Contract #: 04-0120F4Cty: SF/ALA Rte: 80 PM: 13.2/13.9File #: 69.25B**QUALITY ASSURANCE -- NON-CONFORMANCE REPORT****Location:** Changxing Island, Shanghai, PRC**Report No:** NCR-000104**Prime Contractor:** American Bridge/Fluor Enterprises, a JV**Date:** 28-Mar-2008**Submitting Contractor:** Zhenhua Port Machinery Company, Ltd (ZPMC), Changxing Island**NCR #:** ZPMC-0101**Type of problem:**

**Job Name:** SAS Superstructure

**Subject:** NCR No. ZPMC-0101

#### Description of welding discontinuity:

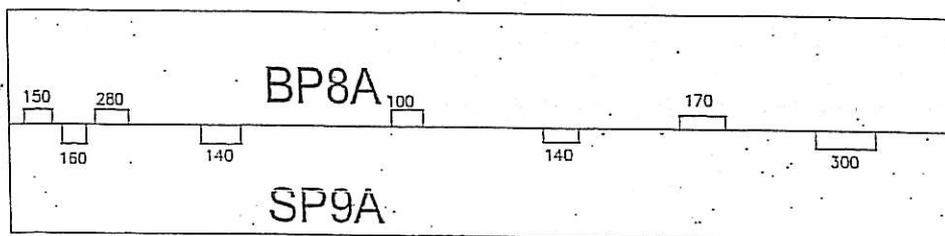
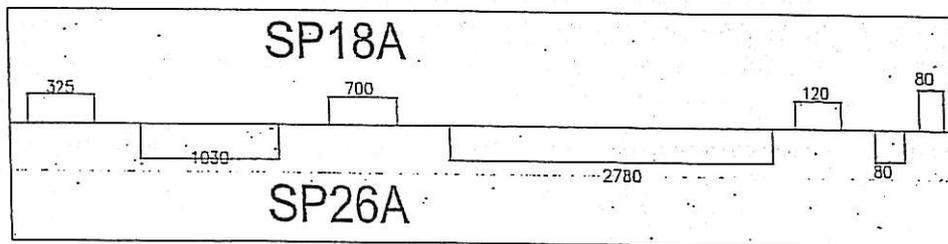
SP18A与SP26A、BP8A与BP9A两拼装配间隙超标, 最大间隙为10.6mm.

During assembling the SP18A and SP26A, BP8A and BP9A, the gap exceeds the maximum allowance; the maximum gap is about 10.6mm.

1. 将尺寸超差部位清洁并打磨使与周边母材平滑过渡;
  2. 根据相应的修补WPS在陶瓷衬垫上对超差区域进行堆焊处理;
  3. 补焊区域打磨至要求的根部间隙;
  4. 对补焊区域进行100%MT及UT检查。
1. Clean the out-of-tolerance area and grind flush to the adjacent base metal.
  2. Welding will be performed of this area on the ceramic backing according to relevant repair WPS.
  3. Grind the repaired area to the requirements of root gap.
  4. Perform 100% MT and UT of this area.
